Access Compliance Report

Public Rights-of-Way

(Curb Ramps)

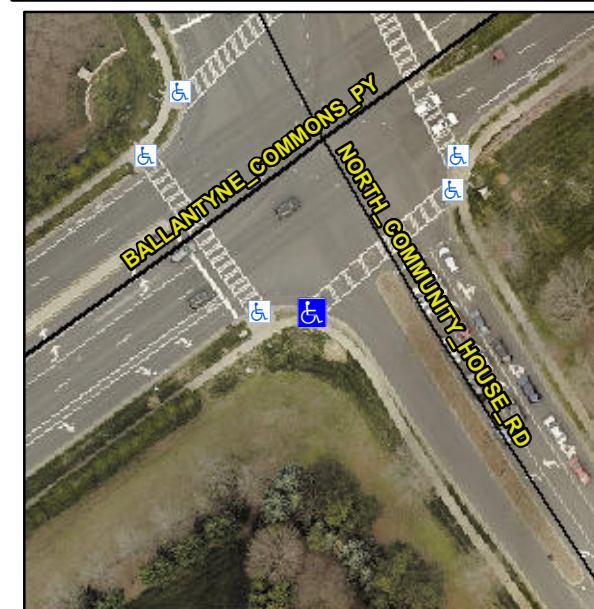
Intersection ID: 27495	Main Street: BALLANTYNE COMMONS PY	Cross Street: NORTH COMMUNITY HOUSE RD	Location: SW
ADA ID: E0FAE05C4D91	Ramp Type: Perp	Initial Pass/Fail: Fail	Overall Compliance: No
Codes/Mitigation Info/Possible Solution		Field Measurements/Component Compliance	
Severity Score: 33.75

Not Found, R304.5.1, R304.5.3

Compliance	Description	Data	Compliance	Description	Data
N/A	Ramp Length (in)	25.0	Yes	Ramp Slope (%)	5.5
No	Ramp Width (in)	47.0	No	Ramp XSlope (%)	7.5
N/A	Flare Type LT	N/A	N/A	Flare Type RT	N/A
N/A	Flare Slope LT (%)	N/A	N/A	Flare Slope RT (%)	N/A
N/A	Flare Traversable LT?	N/A	N/A	Flare Traversable RT?	N/A
N/A	Landing Length (in)	N/A	N/A	DWS Provided?	N/A
N/A	Landing Width (in)	N/A	N/A	DWS Contrast?	N/A
N/A	Landing Slope (%)	N/A	N/A	DWS Length (in)	N/A
N/A	Landing X Slope (%)	N/A	N/A	DWS Full Width?	N/A
N/A	Landing Curb? (Y/N)	N/A	N/A	DWS Offset (in)	N/A
N/A	Shared Landing?	N/A			
N/A	Gutter Ponding?	N/A	N/A	Gutter Slope (%)	N/A
N/A	Gutter Lip Ht (in)	N/A	N/A	Gutter X Slope (%)	N/A
N/A	Painted X Walk1?	Yes	N/A	Painted X Walk2?	N/A
	X Walk 1 Direction	To NE		X Walk 2 Direction	N/A
N/A	X Walk 1 Width (in)	125.0	N/A	X Walk 2 Width (in)	N/A
	X Walk 1 Slope (%)	4.4		X Walk 2 Slope (%)	N/A
	X Walk 1 X Slope (%)	3.7		X Walk 2 X Slope (%)	N/A

Remove & Replace Entire Ramp.
